**W. M. JORDAN COMPANY'S ADDENDUM NO. 1**

**PROJECT: CFCC SA ADDITION**

**DATE: MARCH 17, 2025**

3 SCIENCE LAB 130 - WEST  
SCALE: 1/4" = 1'-0"

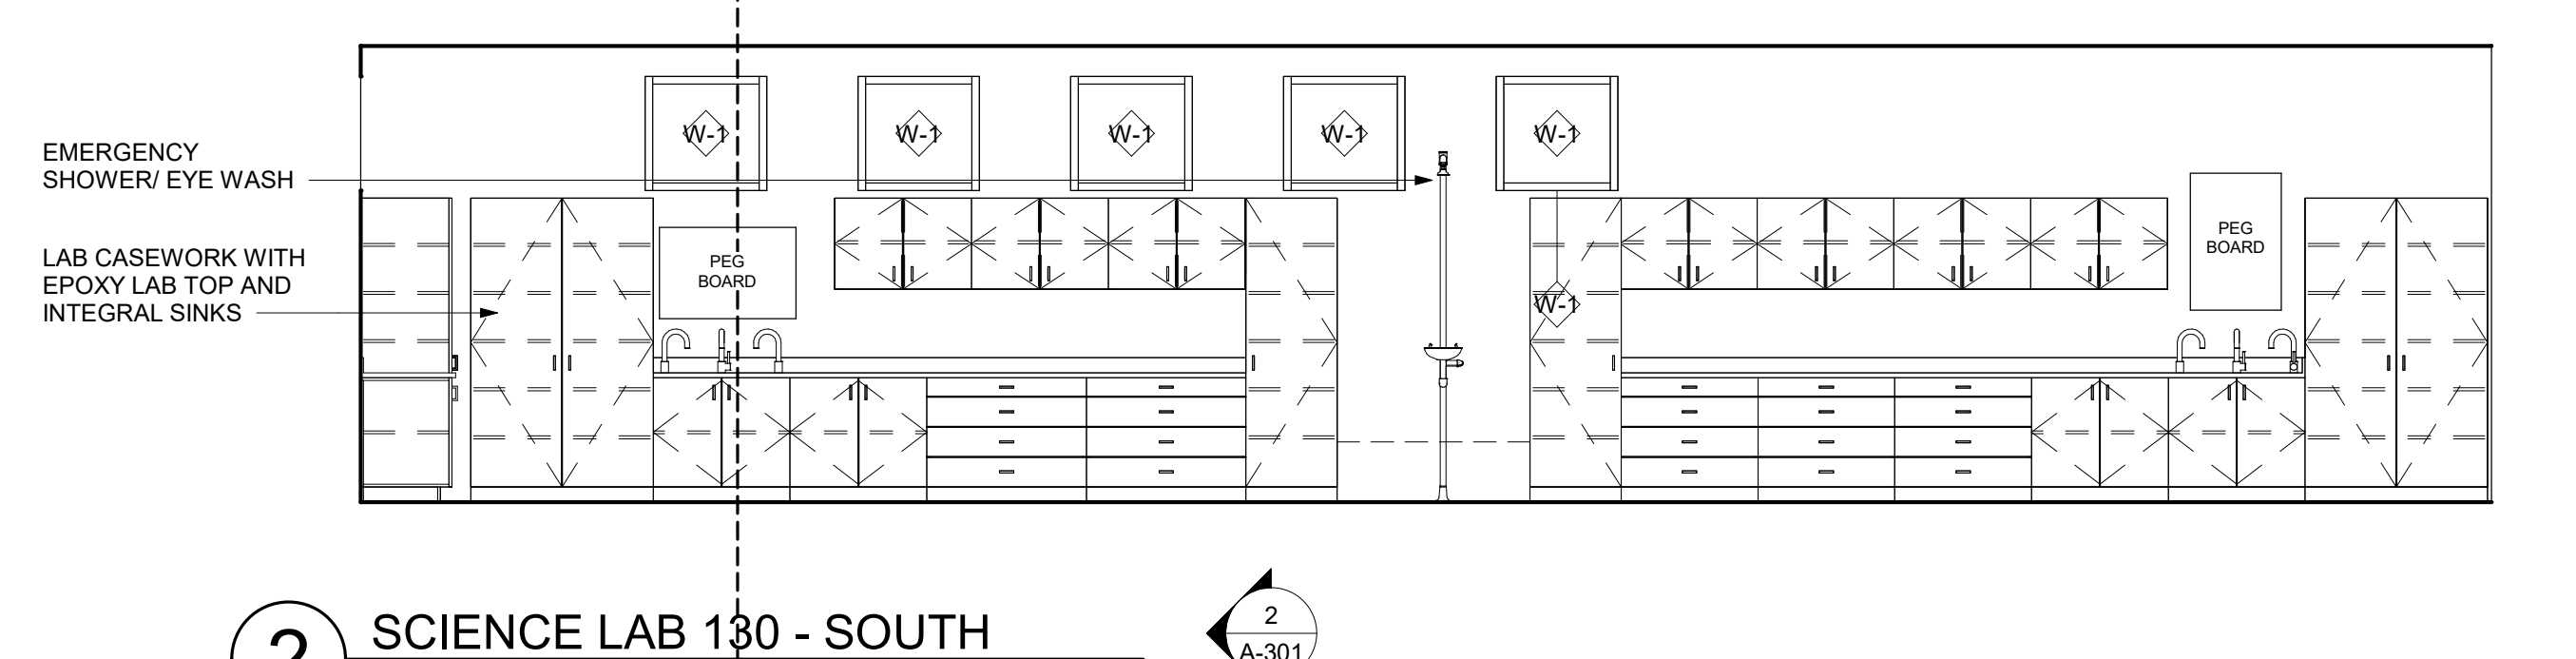
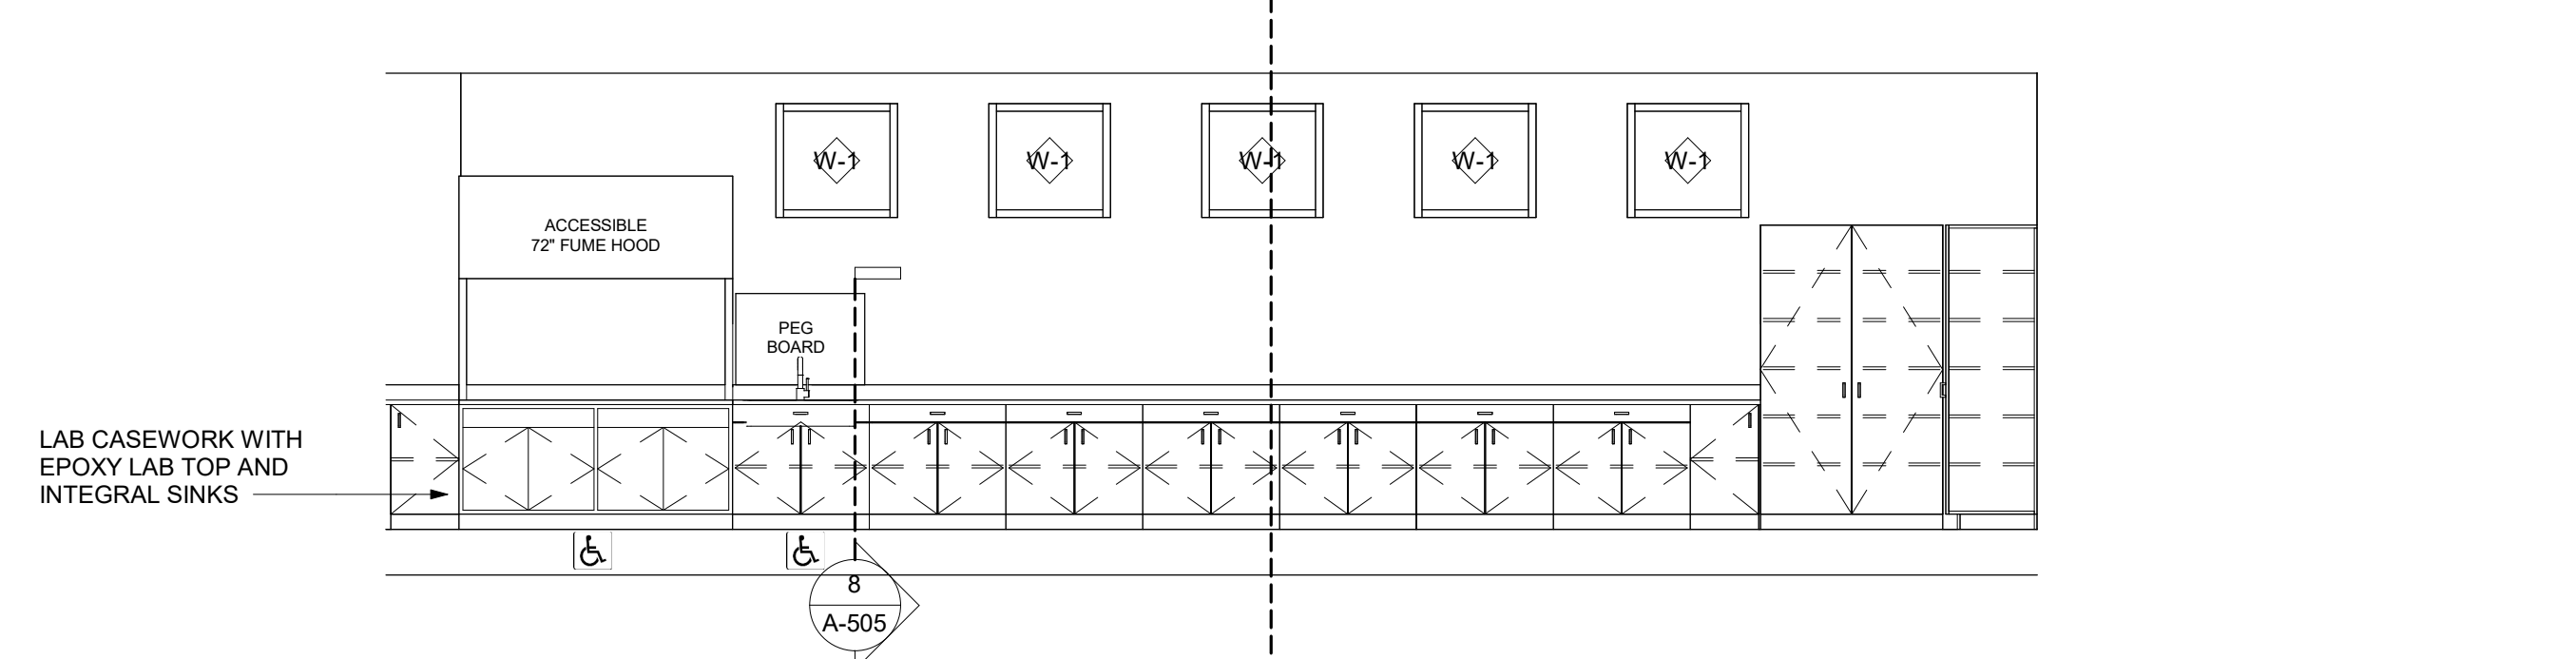
- Answer: Section 123553.19 Wood Laboratory Casework and Section 123552.16 have been added to the bid documents. The intent if for the manufacturer to provide the most cost-effective solution using one of the mentioned scopes. Elevation 3 on A-402 should be included in the base bid. Please provide alternate pricing to furnish and install the most cost-effective solution. Base bid is for plastic laminate, alternate will be for wood. See bid form.

4. *Provide and install one (1) 72" and one (1) 60" Fume Hood with Flammable and Acid Waste Storage Cabinets.*
5. *Provide deduct to not include furnishing and installing plastic laminate casework as shown on detail 3, A-402.*
